## U.S. Department of Energy

September 6, 2005

Subject: Response to the Request for Additional Information on "Field Procedures for the Radiological Excavation Control and Radiological Verification of the Moab Project Site"

*Decision Tree for Interior and Exterior*

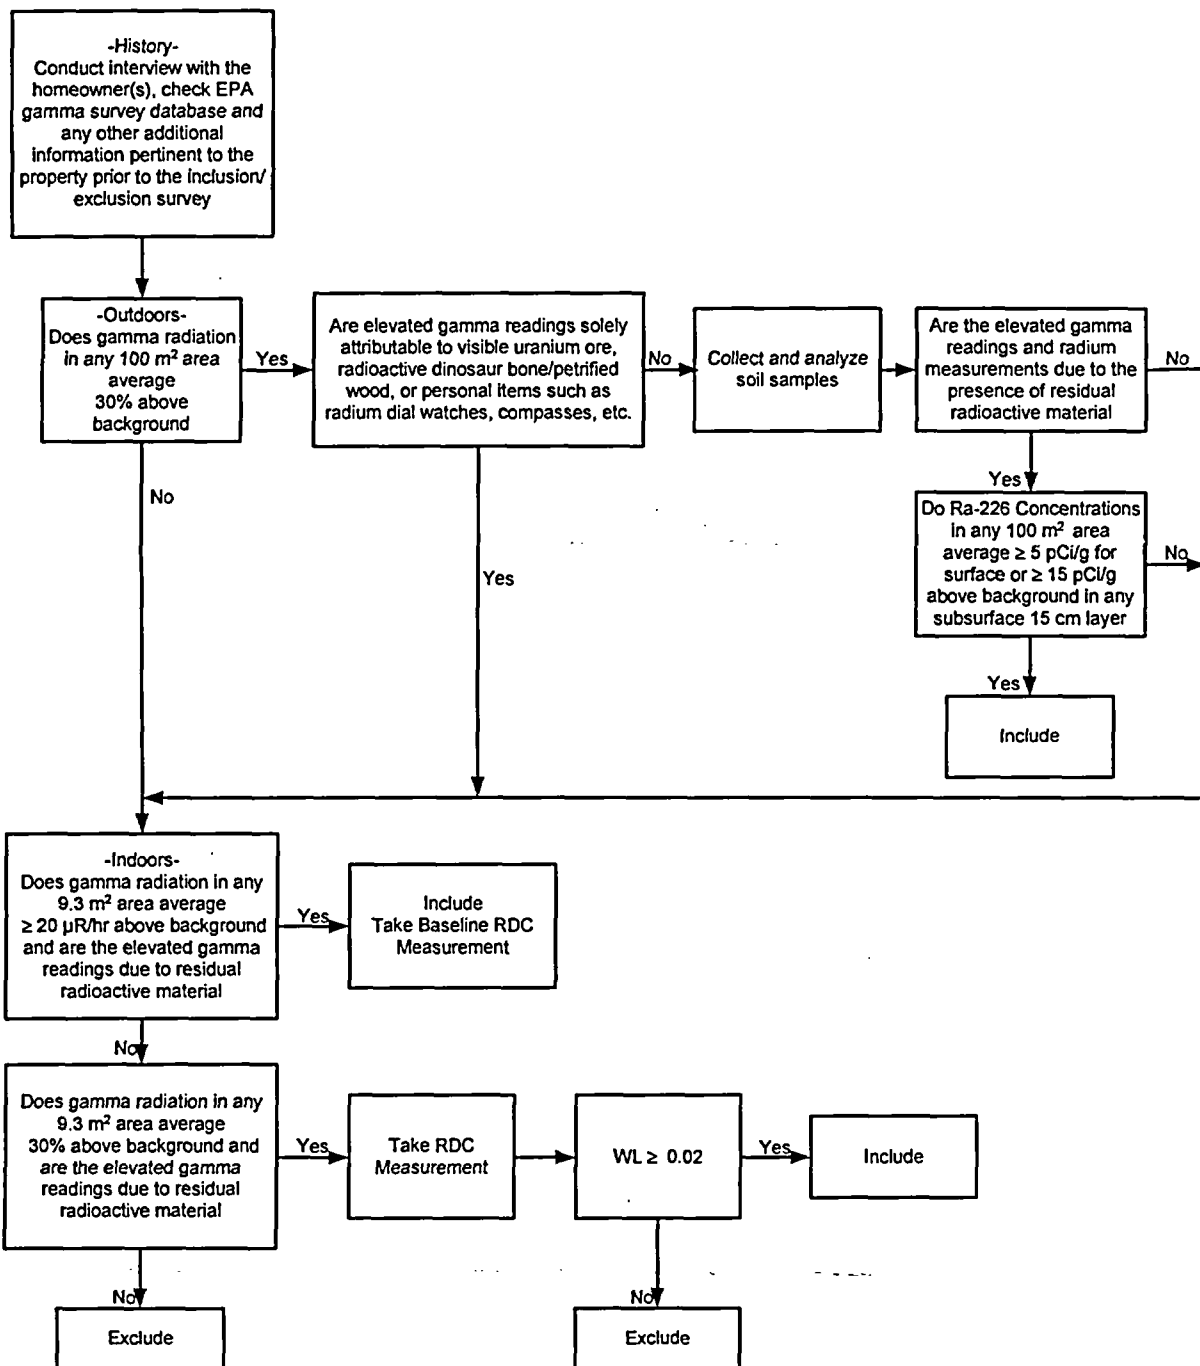
Attachment 1, Page 4, Section 2.4

The inclusion/exclusion survey decision tree (enclosed) and associated text in Attachment 1 will be revised to correct the inconsistency for initiating soil sampling for inclusion purposes when the gamma exposure rate is 30-percent above background (1.3 times background) averaged over a 100 square meter area. This change should address concerns of buried tailings deposits that might have been missed using the 25  $\mu$ R/h above background criterion.
